March 11, 2024

TO : All Bidders
FROM : Bob Lavey
PROJECT : Nogales High School New Building and Aquatic Center
Project W2110000AR.41
DSA : 03-122782 / File 19-92
SUBJECT : Addendum 3

DRAWING NUMBER: **A2.3**

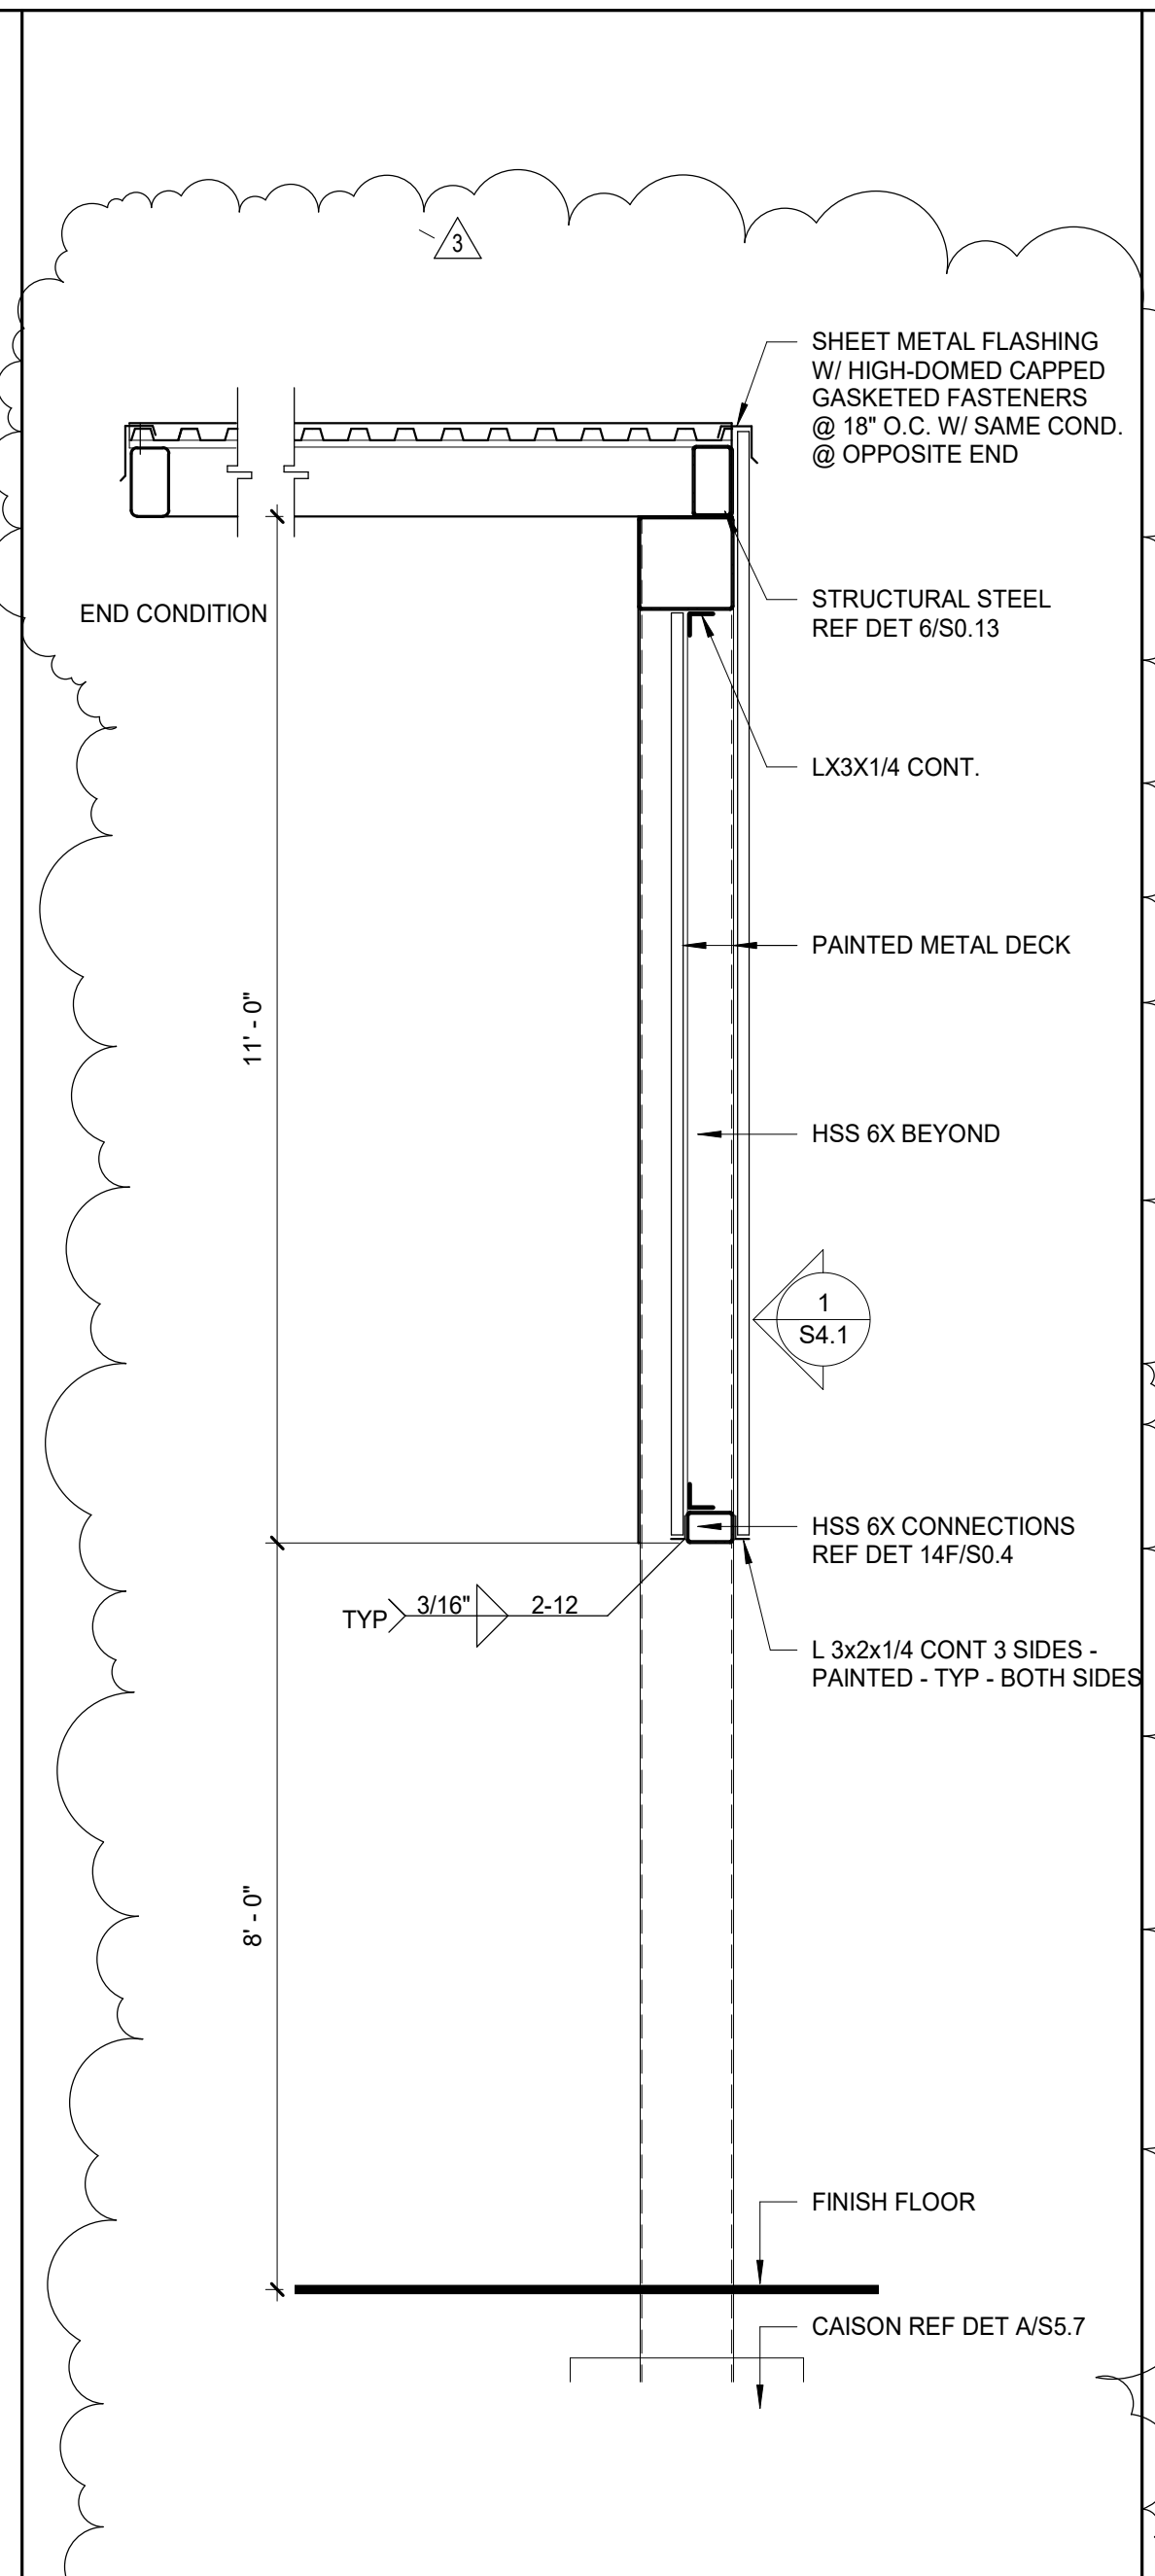
- A. Remove casework from scope of work in northeast corner of Room A140 to make room for electrical panels per the attached Drawing A2.3.

COVERED WALKWAY END 1/2" = 1'-0" 18

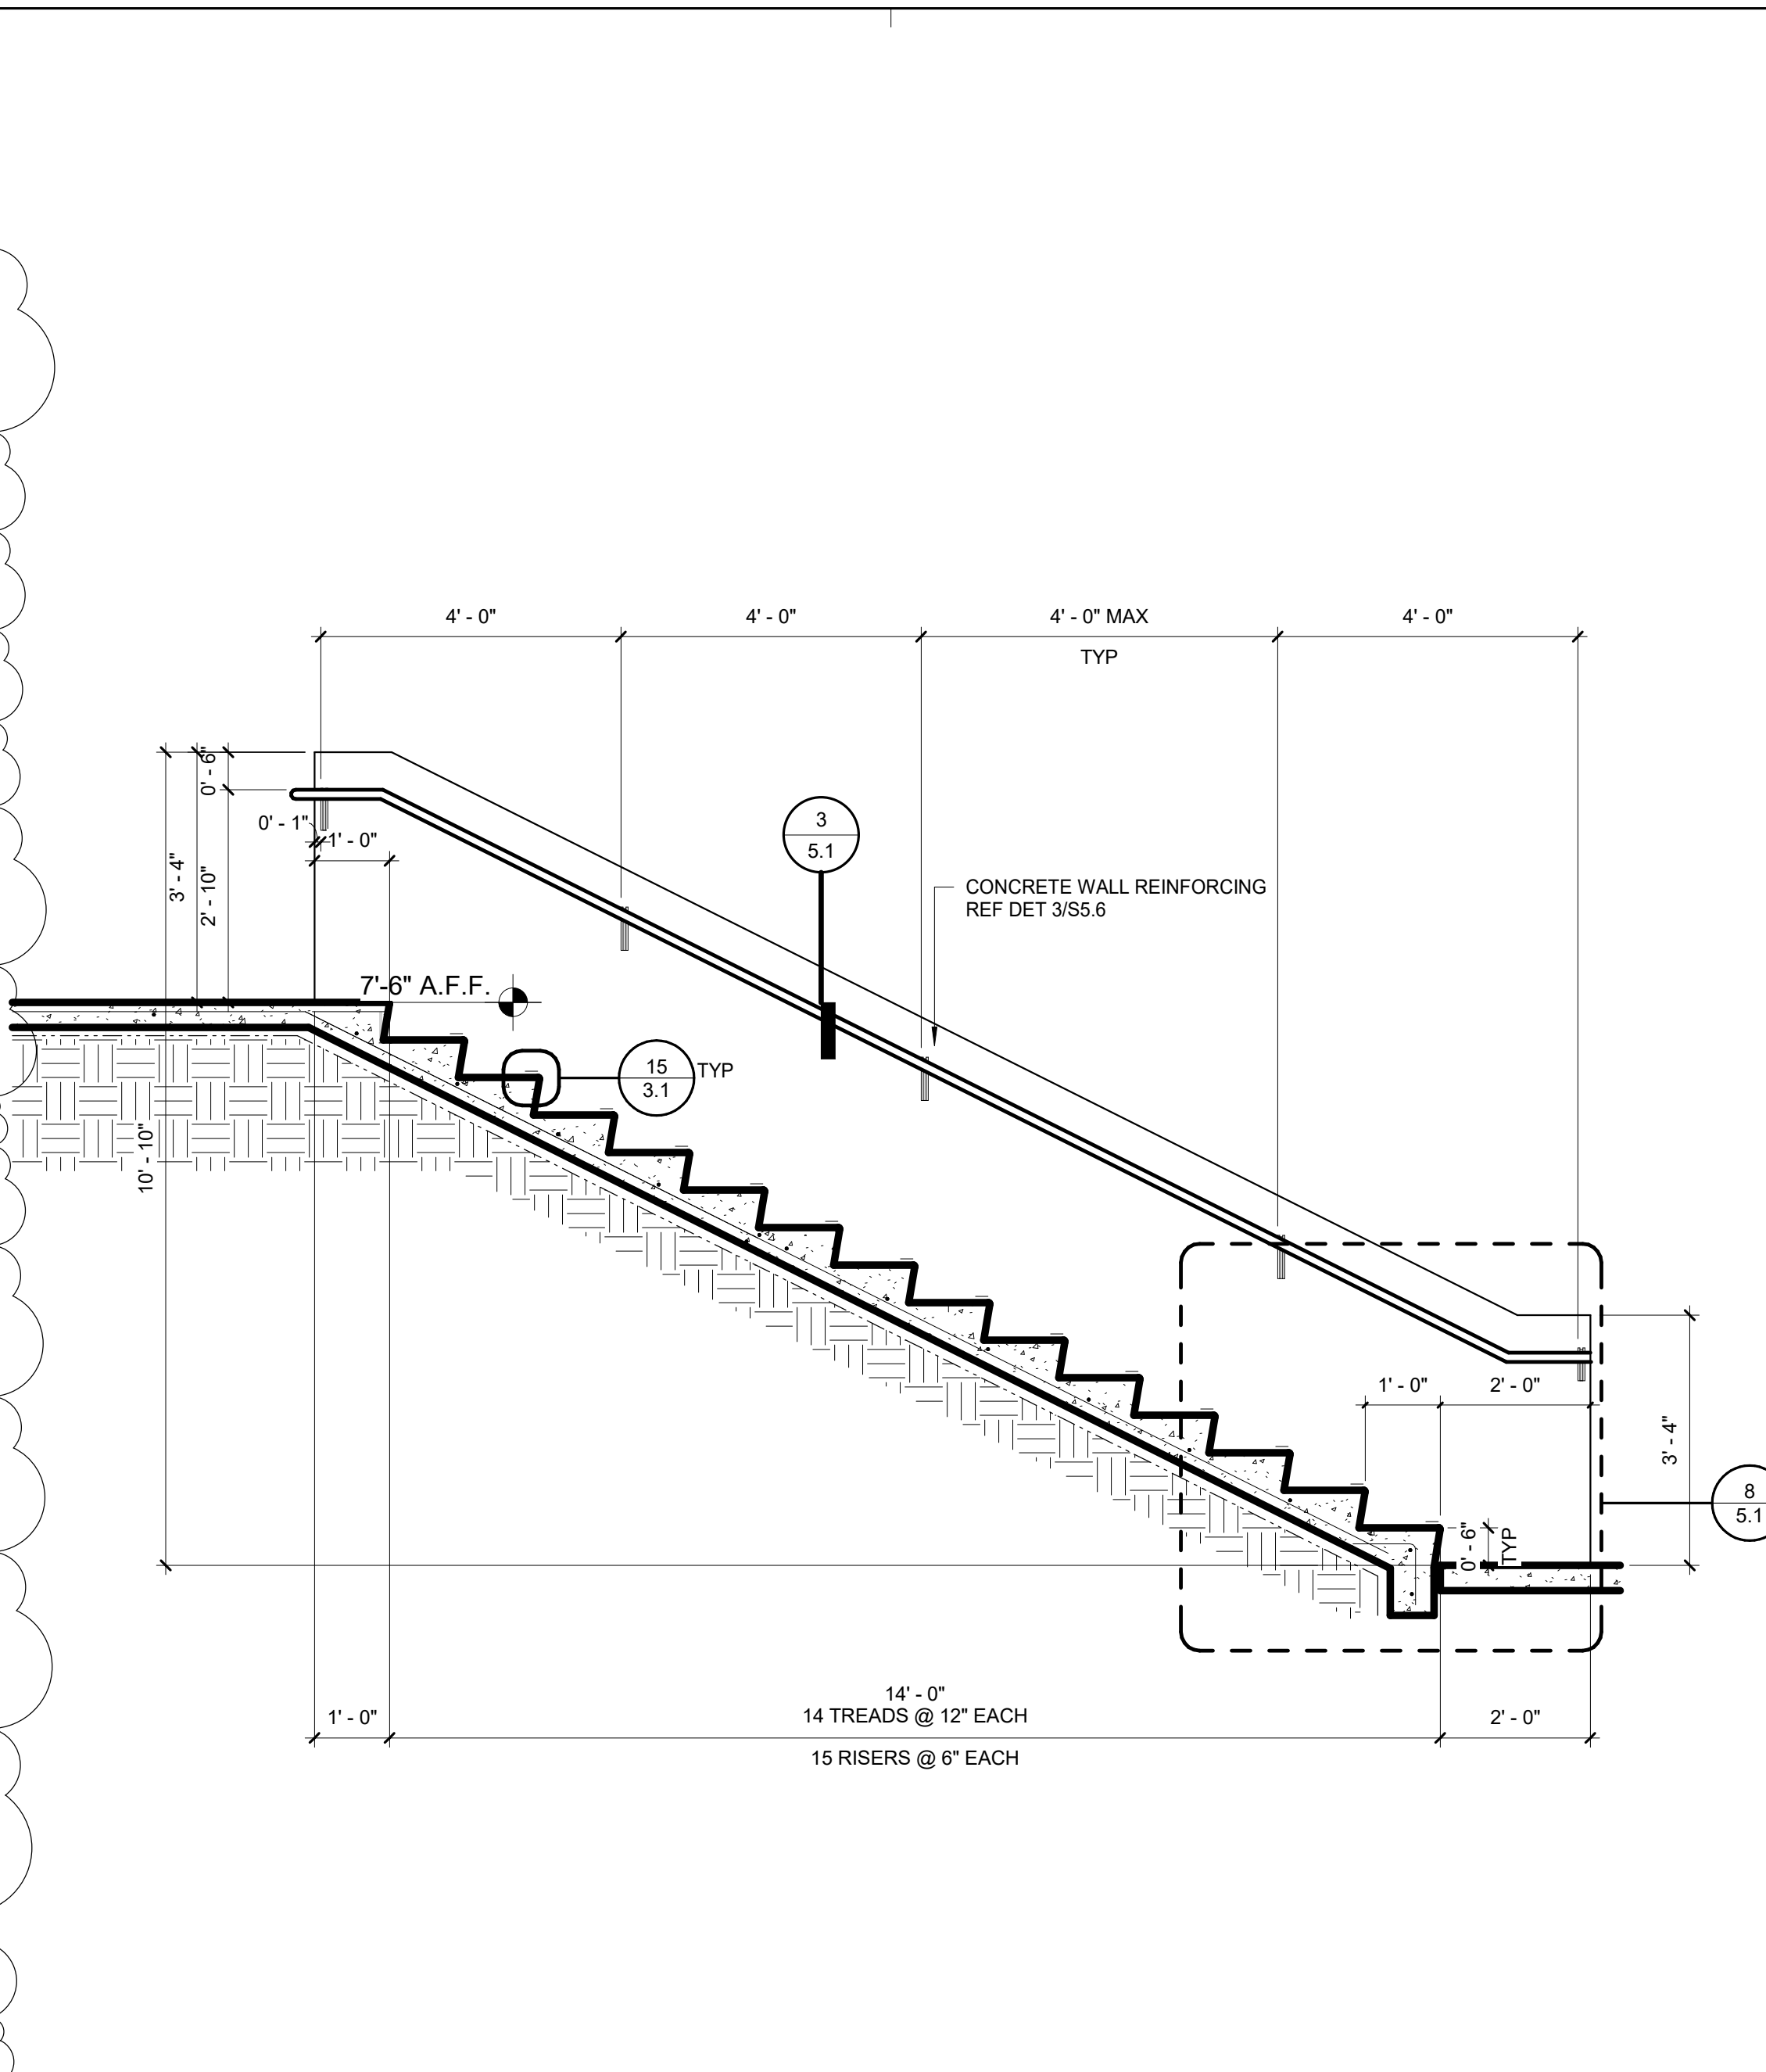
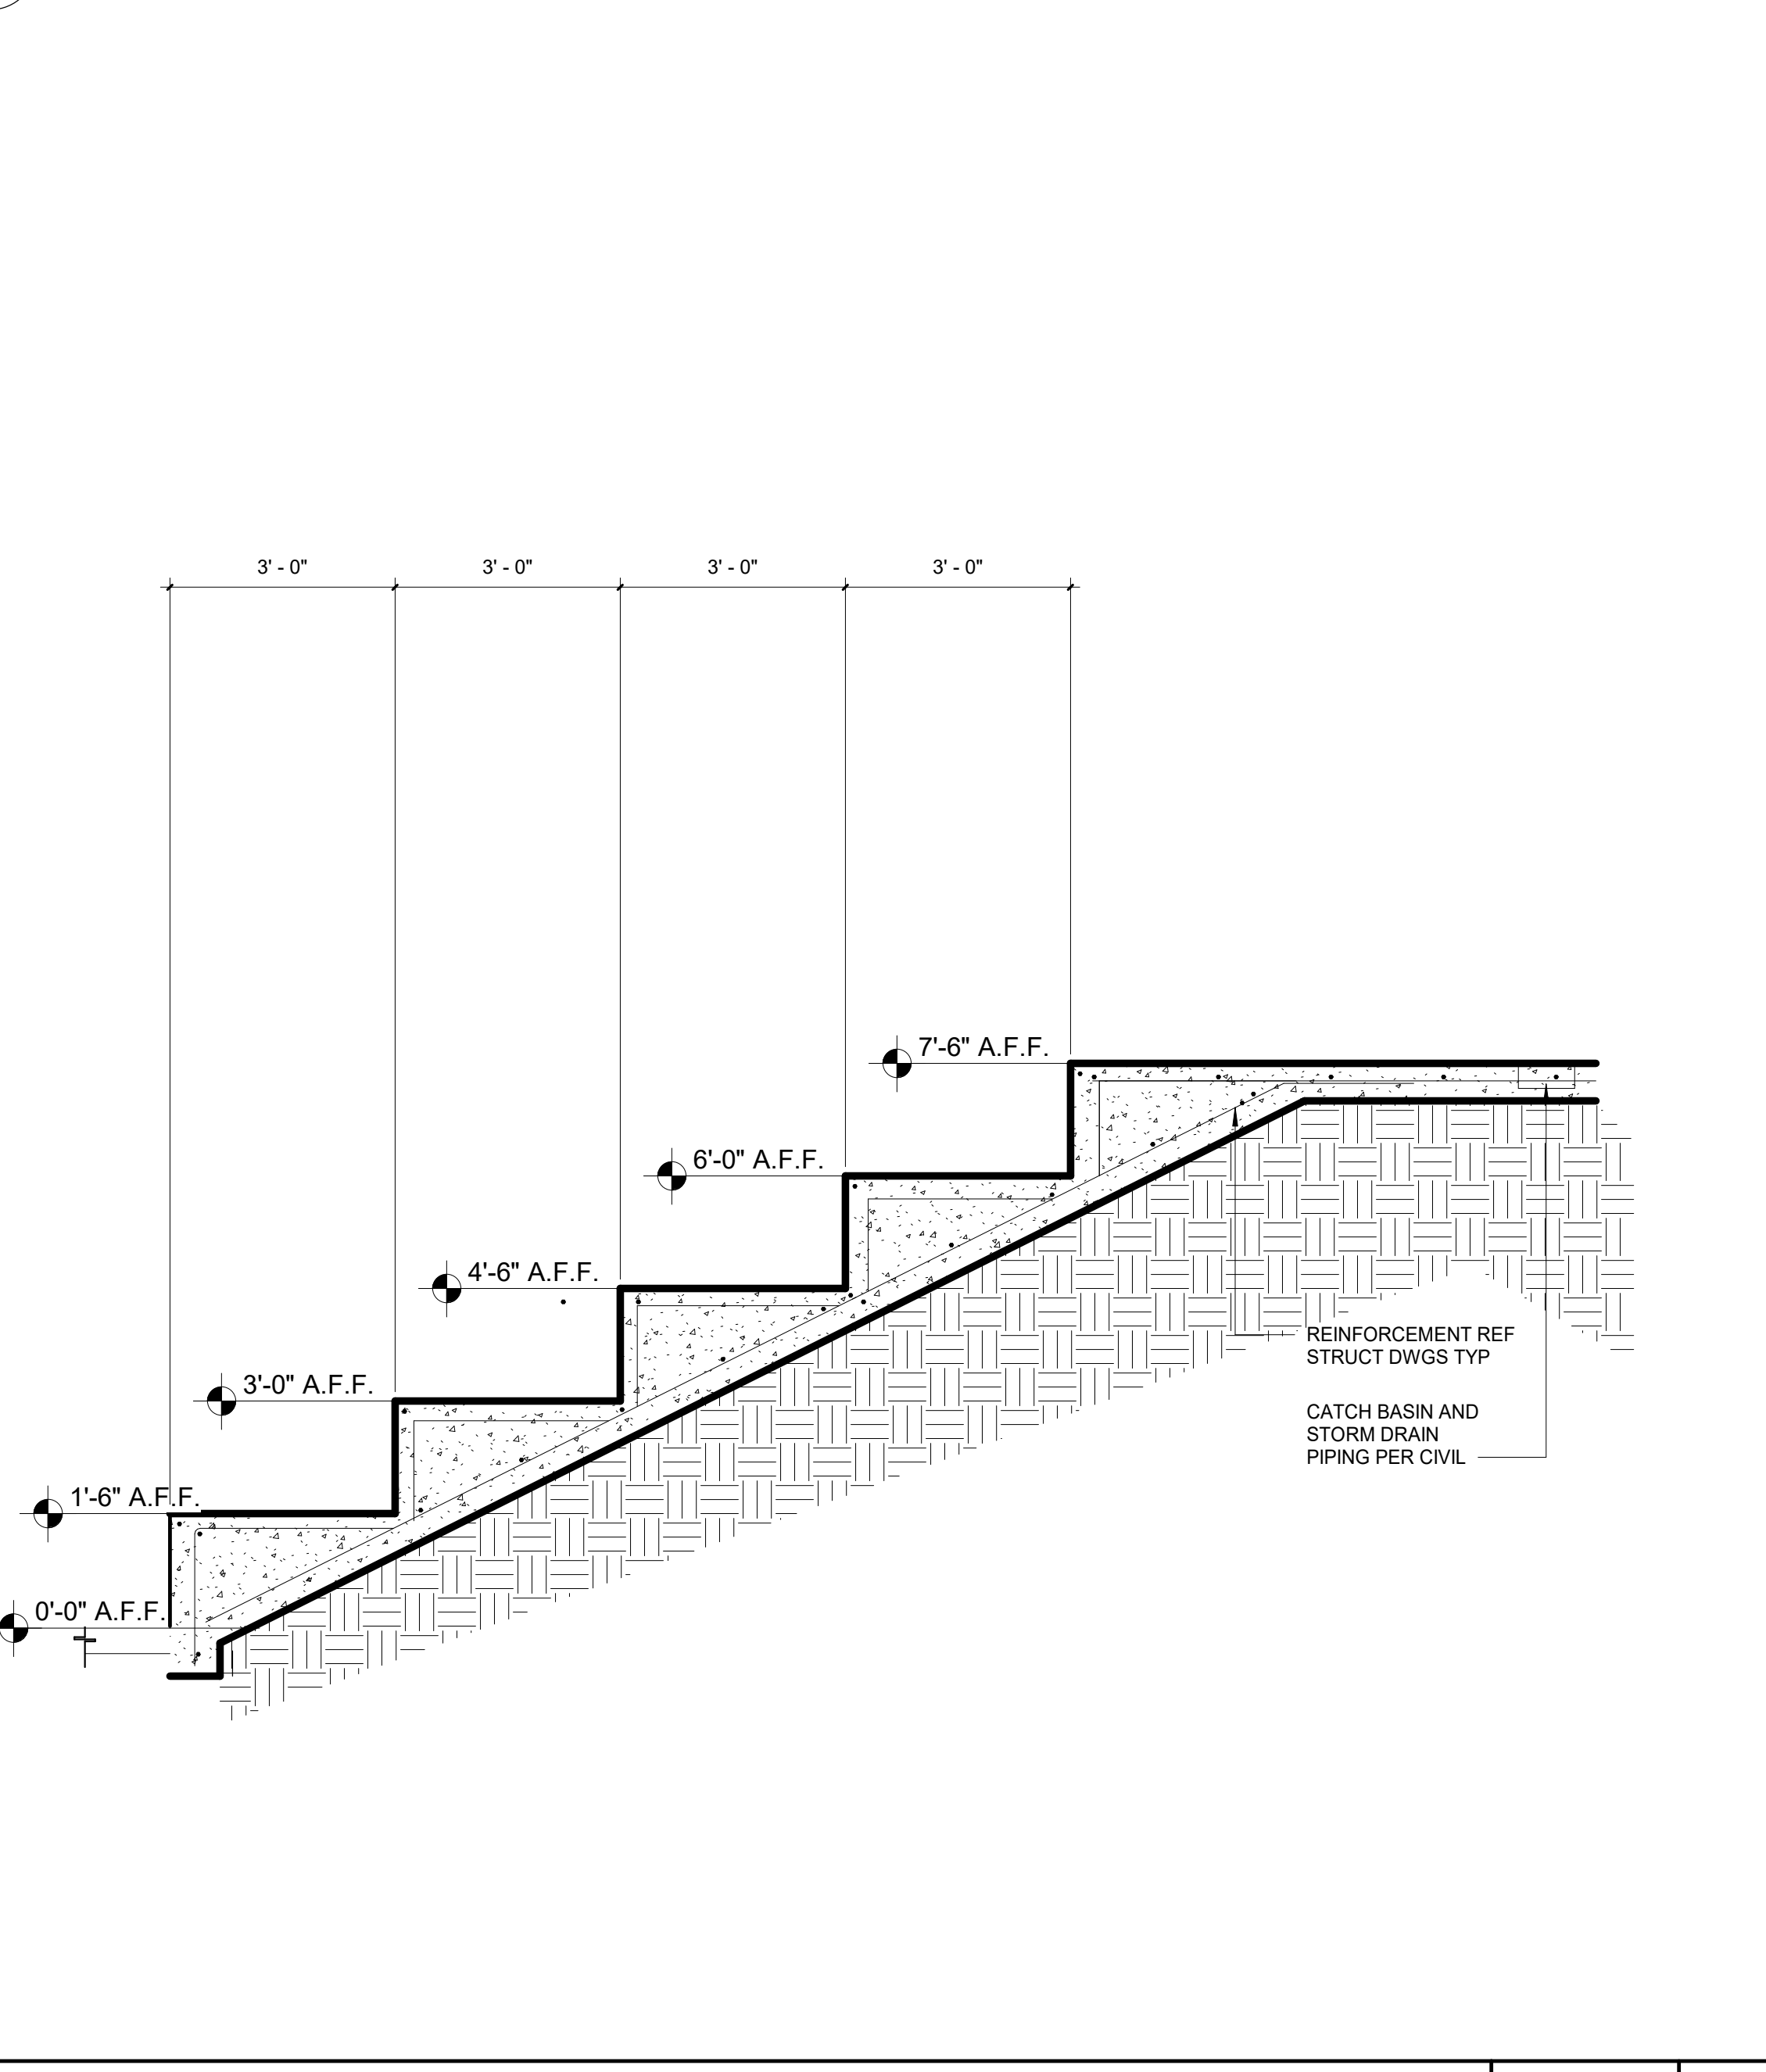
- A. Replace this drawing in its entirety with the attached Drawing A5.5.
- B. Detail 18: Revise detail notes and add end condition.
- C. Detail 20: Revise low wall top condition and wall to floor transition.
